CHANGE ORDER NO 1 (#2018.007)
(Title of Document)

Project: NVWWTP Effluent Storage Reservoir Repair Project	Owner: Douglas County	Owner's Contract No.: 2017-100
Contract: NVWWTP Effluent Storage Reservoir Repair Project	Date of Contract: July 6, 2017	
Contractor: Walter M. Lee dba Z7 Development	Engineer's Project No.: 2017-100

NVWWTP Effluent Storage Reservoir Repair Project
Exhibit A - Change Order No. 1 Summary

NVWWTP Effluent Storage Reservoir Repair Project
Exhibit B – Work Change Directive No. 1

Exhibit B – Location of Borrow Area, Approximately 70' by 100'

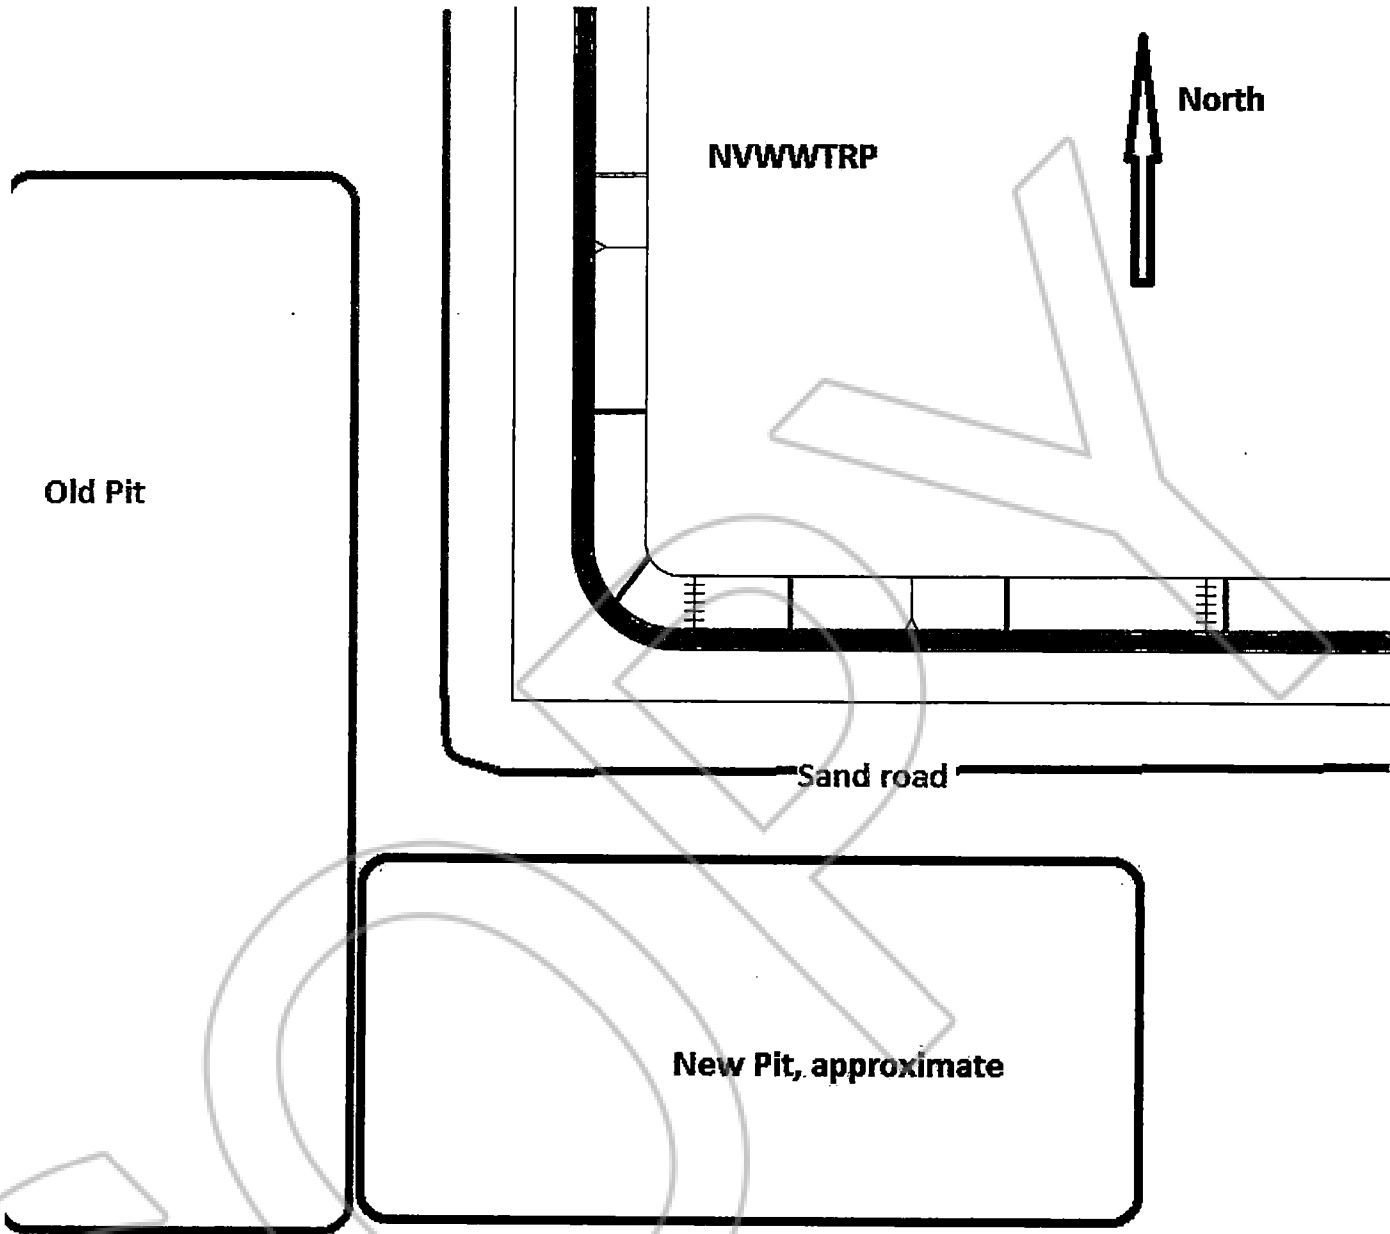
- b) The general location of the borrow area is shown in Exhibit B. Upon completion of work, the borrow area shall be graded uniformly, slopes flattened, and material that was removed in clearing and grubbing shall be spread over the area and incorporated.
